HISTORIC AND DESIGN REVIEW COMMISSION

HDRC CASE NO: 2019-135
ADDRESS: 309 N HACKBERRY ST
LEGAL DESCRIPTION: NCB 583 BLK 8 LOT 16 AND 17
ZONING: IDZ, H
CITY COUNCIL DIST.: 2
DISTRICT: Dignowity Hill Historic District
APPLICANT: Kris Feldmann/Square West LLC
OWNER: Kris Feldmann/ Square West LLC
TYPE OF WORK: Fenestration modifications and window replacement
APPLICATION RECEIVED: March 12, 2019
60-DAY REVIEW: May 11, 2019
CASE MANAGER: Huy Pham

REQUEST:

The applicant is requesting a Certificate of Appropriateness for approval to replace non-original windows by relocating original interior wood windows.

A101
FLOOR PLAN
CREO PROJECT #: SW-01

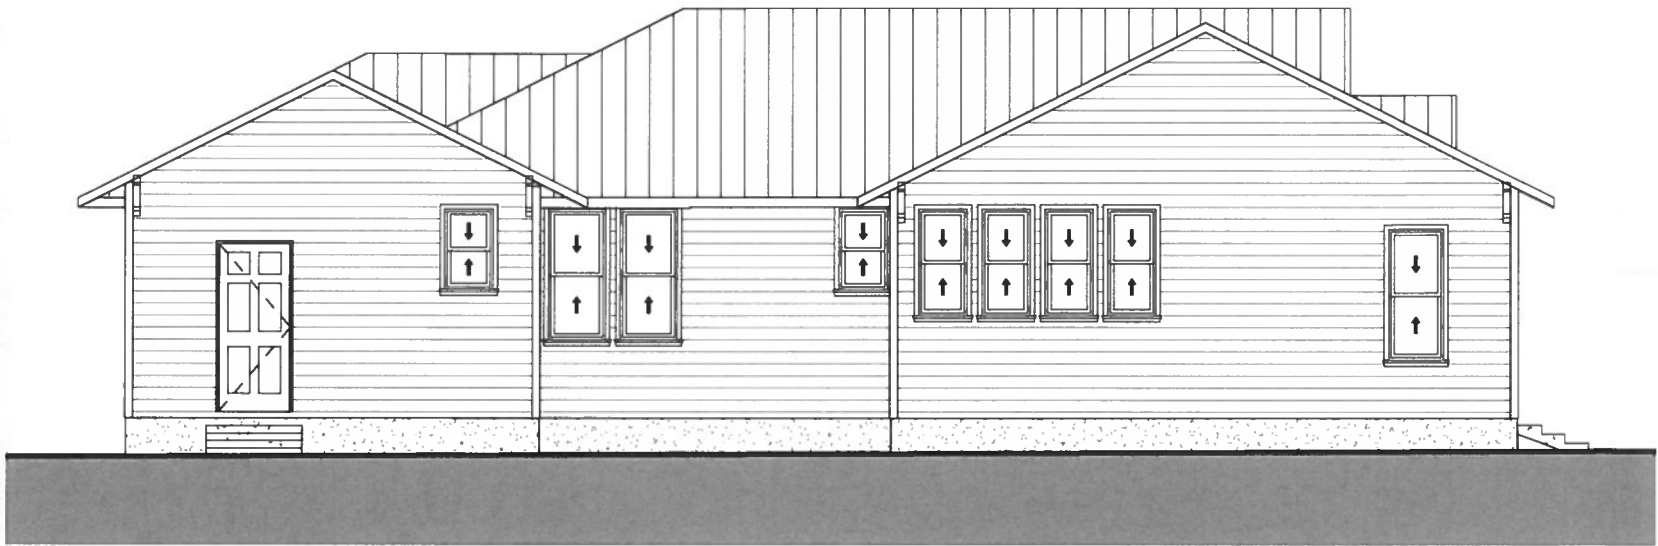
- c. WINDOW REPLACEMENT – The applicant has proposed to replace three (3) non-original casement window in the front porch enclosure with five (5) original wood windows that are currently in an interior wall of the house. The two front façade windows will be replaced with a set of two (2) sashed windows, each flanking the center door in a symmetrical configuration. The side elevation window will be replaced with one (1) sashed window, reducing the size of the window opening. Per the Guidelines for Exterior Alterations and Maintenance 2.6.B.vii. non-historic, incompatible windows should be replaced with windows that are typical of the architectural style of the building. Staff finds that the proposal is generally consistent with the Guidelines; however, staff finds that the configuration of the three-window set should be preserved and not separated. If the non-original door in the non-original porch enclosure needs to be relocated to accommodate the three-window set, then staff finds that to be appropriate. Additionally, the original window openings should be preserved in a manner that allows the windows to return to their original location one chooses to remove the rear addition and restore the structure to its original footprint and configuration.

- i. The set of three windows must remain together and share a block frame as it was installed in the original location. The non-original front door may be relocated to accommodate this stipulation.
- ii. The original window openings should be preserved in a manner that allows the windows to return to their original location if one chooses to remove the addition and restore the structure to its original footprint and fenestration.
- iii. The relocation of the windows should feature matching details to the other original window openings on the structure including trim detail and head height.
